<p>CARNEGIE FORUM 305 WEST PINE STREET LODI, CALIFORNIA</p>	<p>SPECIAL AGENDA LODI SITE PLAN & ARCHITECTURAL REVIEW COMMITTEE</p>	<p><u>SPECIAL SESSION</u> THURSDAY, FEBRUARY 12, 2009 @ 5:15 PM</p>
---	--	--

To: Site Plan and Architectural Review Committee
From: Immanuel Bereket, Assistant Planner, Community Development Department
Date: February 11, 2009
Subject: Request that the Site Plan and Architectural Review Committee review and approve an application to construct a new Taco Bell restaurant at 608 West Lodi Avenue. (Applicant, Dan Lewis; File # 09-SP-01).

TACO BELL
 T-Y07
SITE PLAN

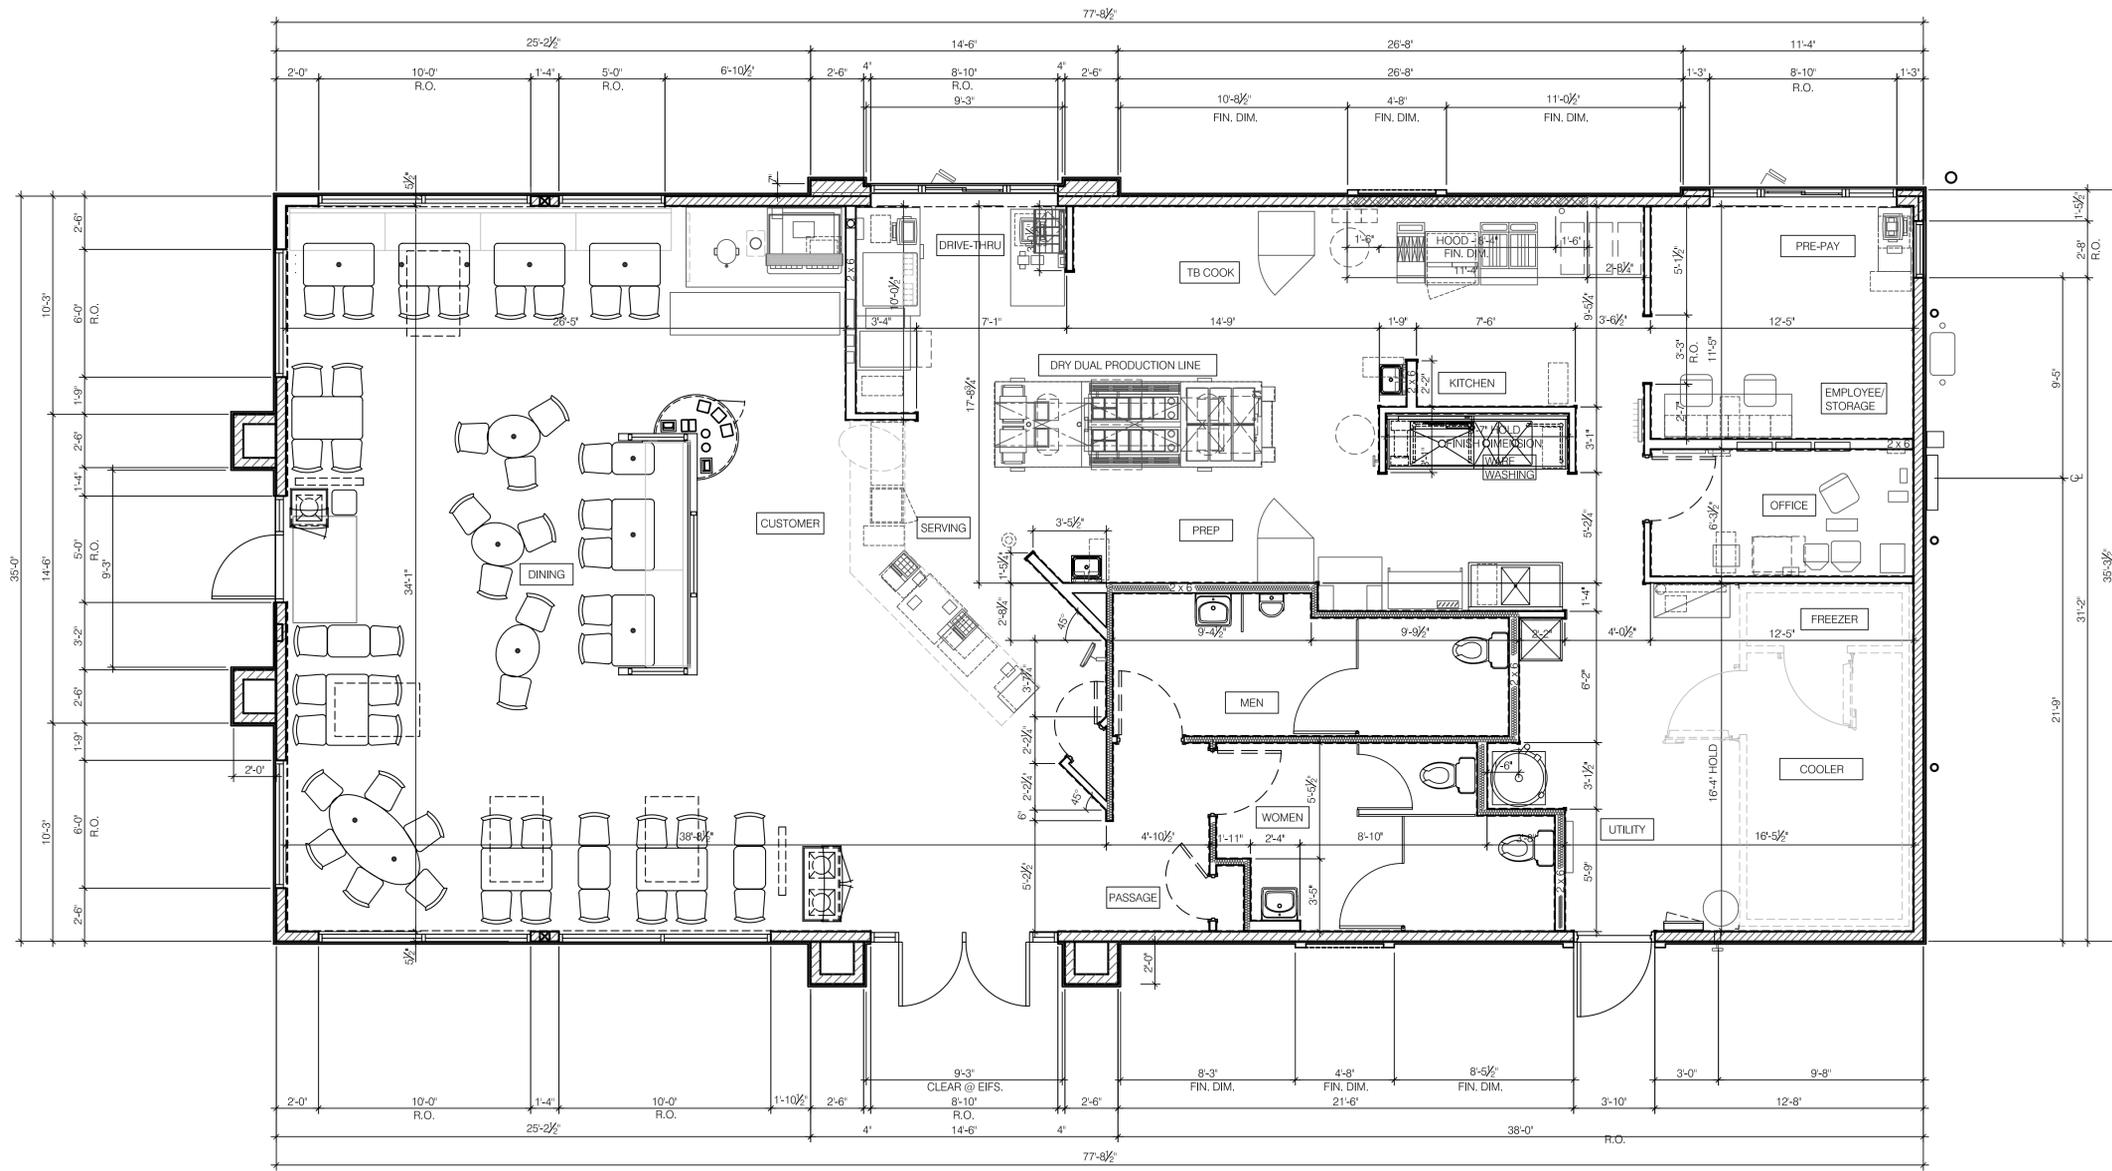
9. Provide a dimensioned site plan showing the existing site layout, proposed site layout, and existing and proposed utilities. Also, show a larger area around the subject parcel for both existing improvements and proposed improvements.

10. The underground utility site plan received by the architect and the underground utility site plan received by the engineer are not consistent. The plans must show the correct storm drain configuration within and around the project area.
